D. S. Fashion Ltd.

Mamun Nagar, Bara Vabanipur, Kasimpur, Gazipur
(23.81179, 90.25374)

10th May 2014

Observations

Non-engineered water tank support structure

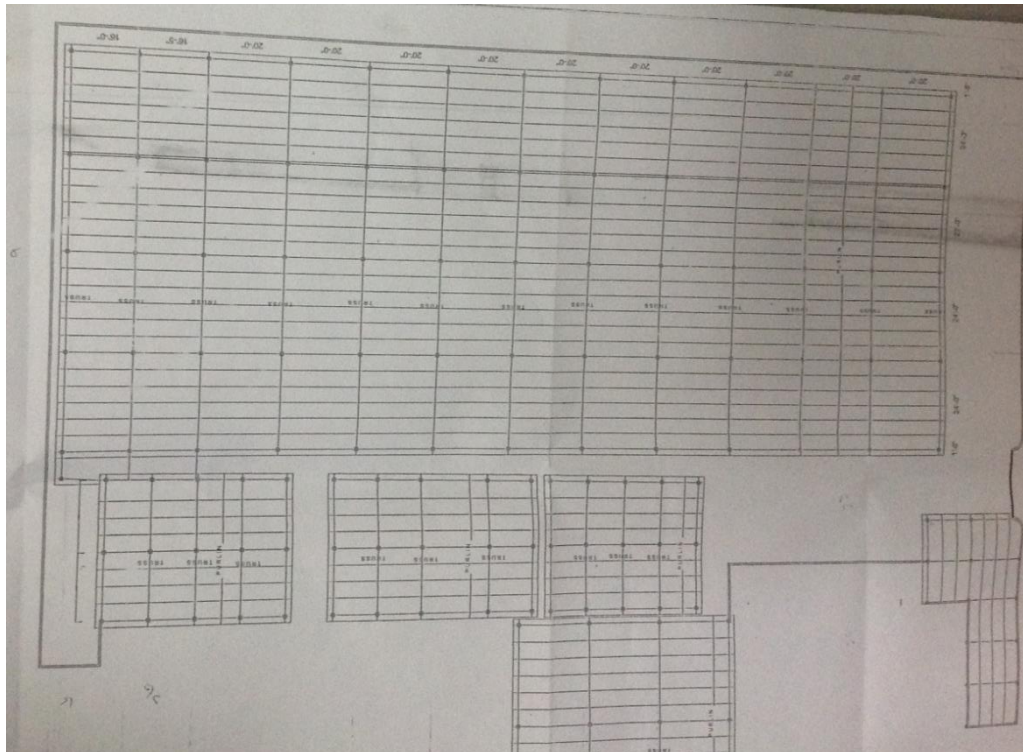
- Support structures for two 2000-litre water tanks were observed on the eastern side of the site, between the Office and the Sample Room.
- The support structure to one tank is concrete framed.
- The other tank is supported by a non-engineered steel frame. This tank is to be emptied to reduce the load until such time as the steel-framed structure is strengthened or replaced as advised by the Building Engineer.

2000 litre tank supported by steel structure
